ADDENDUM TO BID DOCUMENTS

PALO VERDE COLLEGE PROJECT BID NO. 2018-01

PVC COLLEGE SERVICES BUILDING RENOVATIONS

ADDENDUM #2

SHEET NUMBER

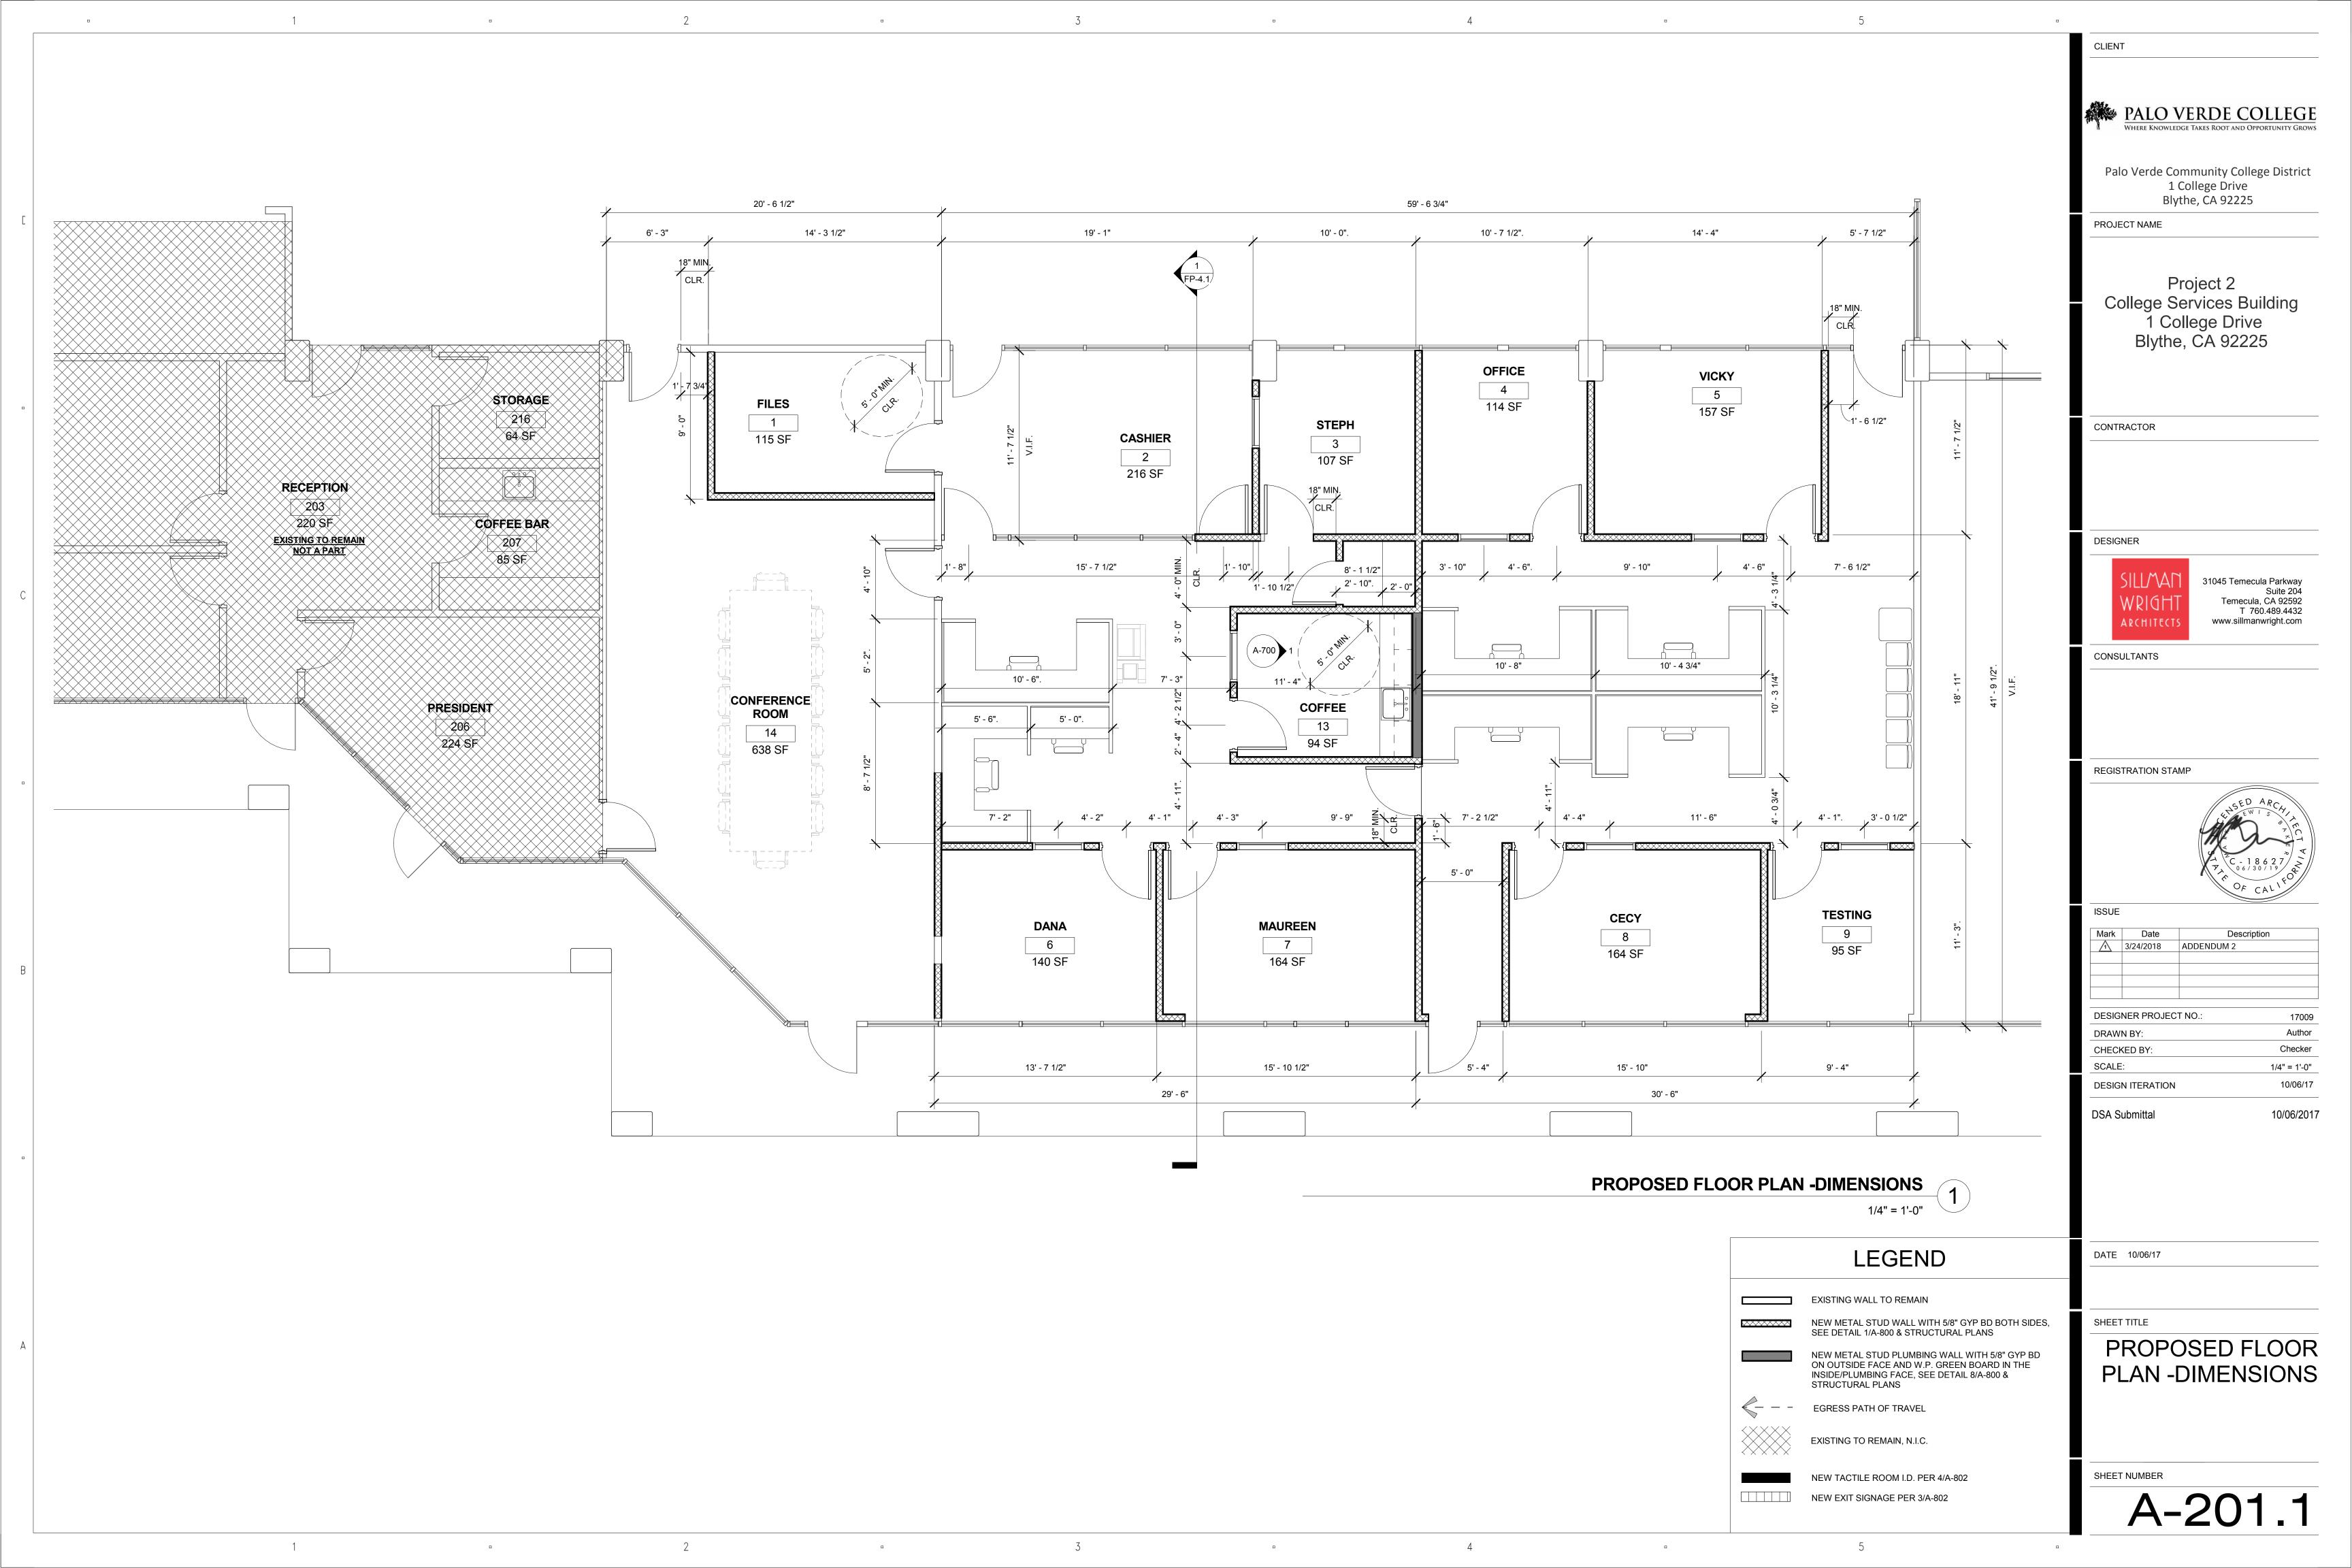
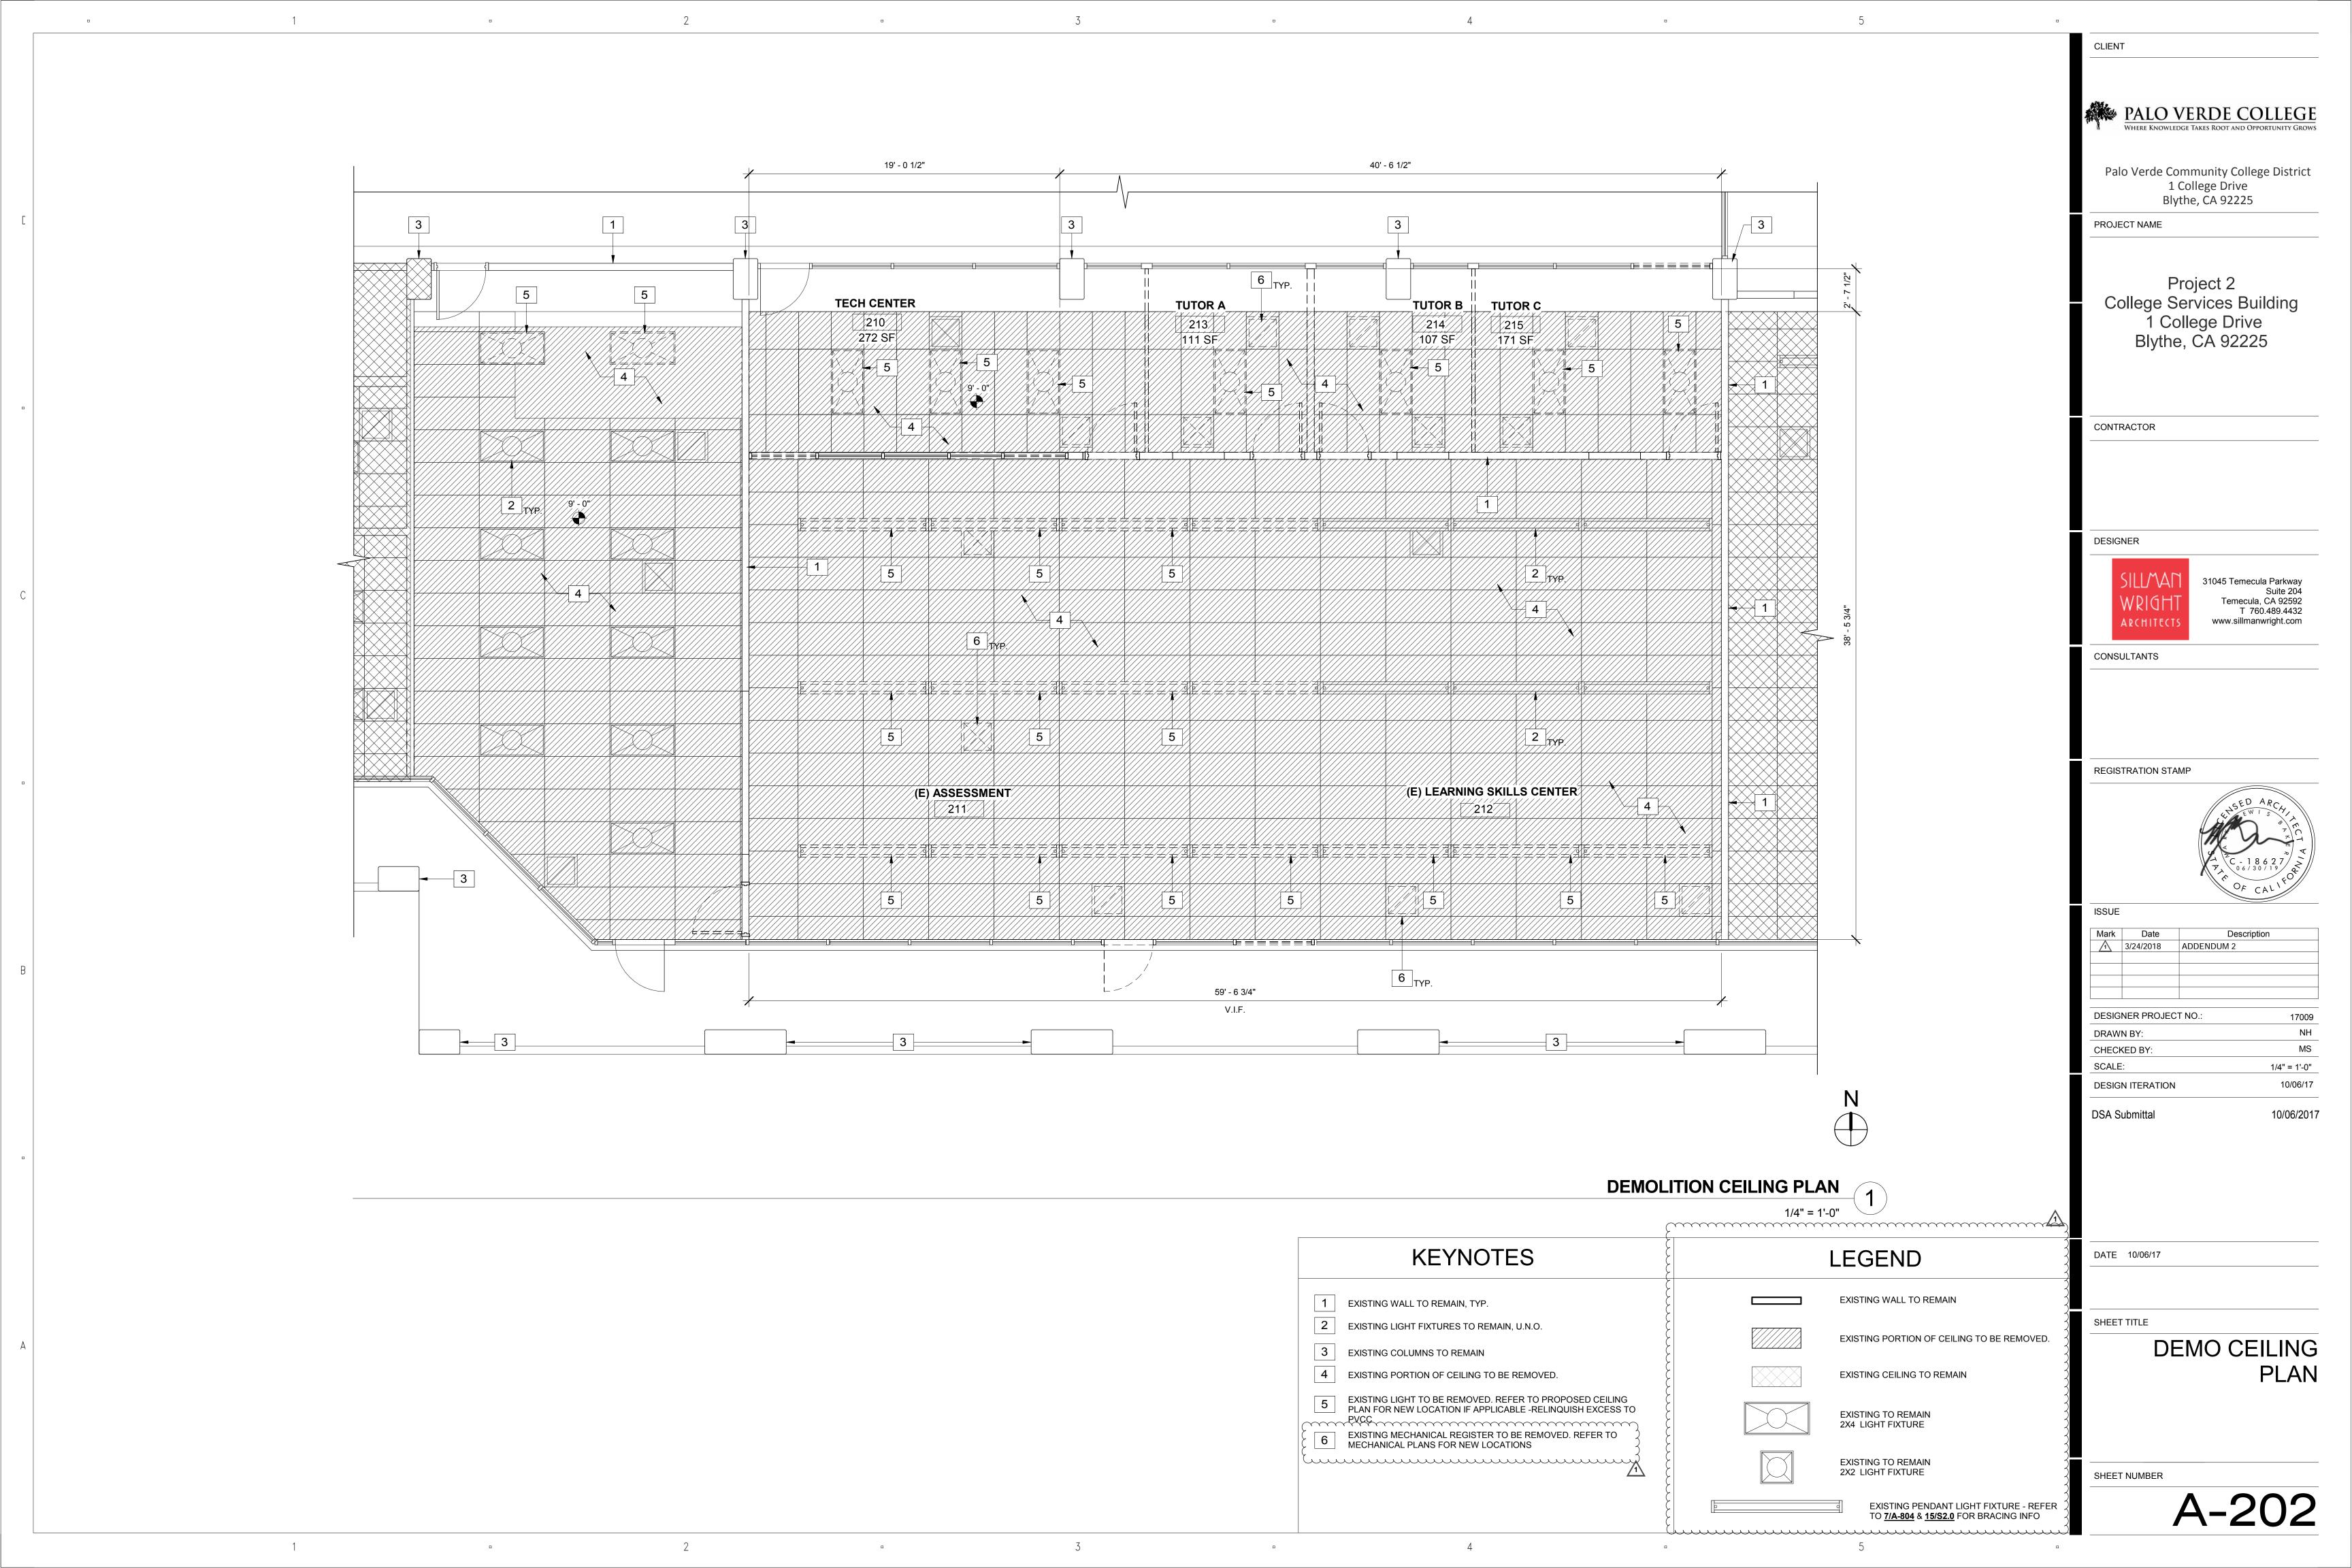
Item 10: Reference Sheet A-700: DOOR SCHEDULE: Door #11, Elevation Type "D" added

Door Elevation Type "B" has been modified to show transom and

side lite

Keynote 2 revised
